PRE-LODGEMENT NOTES – PL-2019/182

17-Dec-2019

Property:	Thirroul Plaza, 282-298 Lawrence Hargrave Drive, THIRROUL NSW 2515 Lot 103 DP 706867	
Proposal:	Mixed Use Development	
Attendees:	<i>Council:</i>	Jessica Saunders – Development Project Officer Will Sale – Development Engineering Officer John Madry – Landscape Officer
	<i>Proponent:</i>	Mark Rigoni – Indesco Stephen Weatherby – Indesco Anthony Barthelmess – Rienco Consulting Alex Scionti – Thirroul Plaza Development Jim Apostolou – AB Works
	<i>Apologies</i>	John Wood – City Wide Planning Manager

Figure 3A.5 Cross section

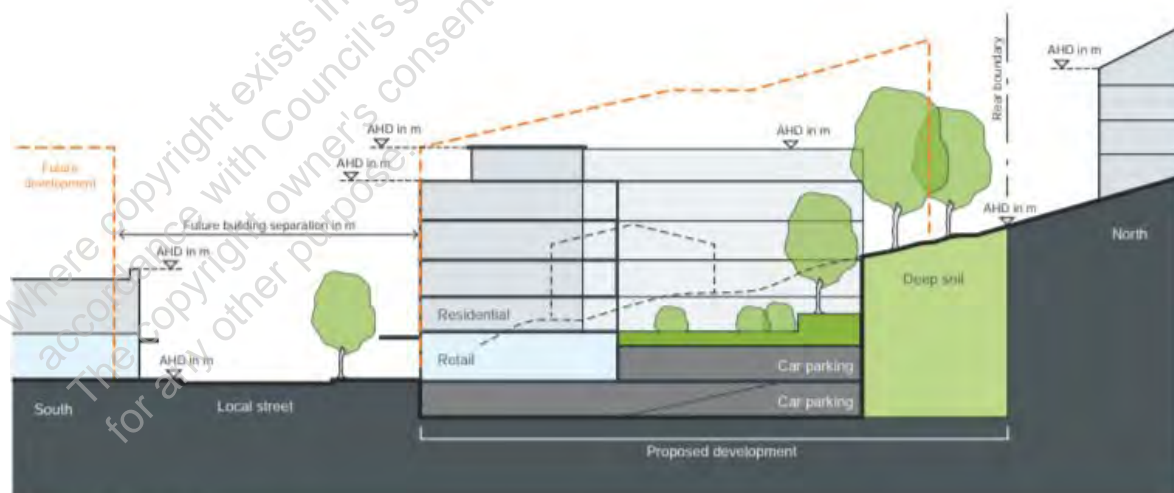
The Apartment Design Guide provides a number of diagrams with regard to how deep soil zones are to be considered, notably the cross section provided at figure 3A.5 and 3E.1, extracted below. The diagrams provided indicate that deep soil zones are not to have any infrastructure beneath them.

The submitted schematic flood storage plan provided with the PL request indicates that the deep soil zone is proposed with dimensions of 4m wide x 1.2m deep. This design would not be considered to satisfy part 3E of the ADG. This area could be considered part of the overall landscaped area for the site, but would not be considered deep soil zone.

It is not considered that the area shown would satisfy this definition.

An alternate design which provides for additional areas for deep soil planting should be explored.

Figure 3E.1 Opportunities for deep soil zones are increased when parking levels are contained within the building footprint

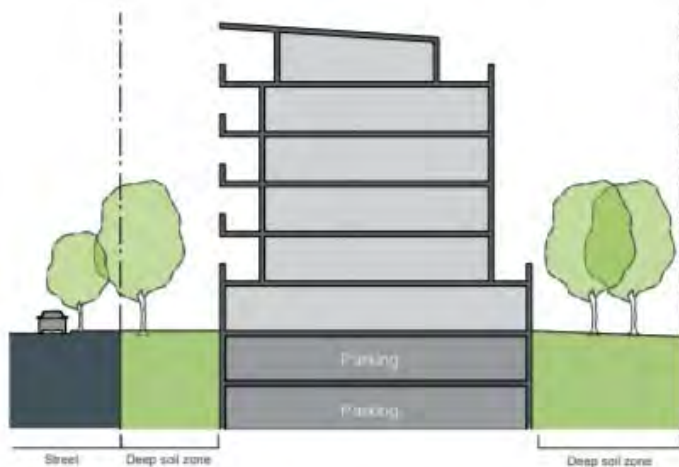
For a site with an area in excess of 1500sqm, Objective 3E-1 requires deep soil zones to have a minimum dimension of 6m, and a total area of 7% of the site is to be provided as deep soil zone.
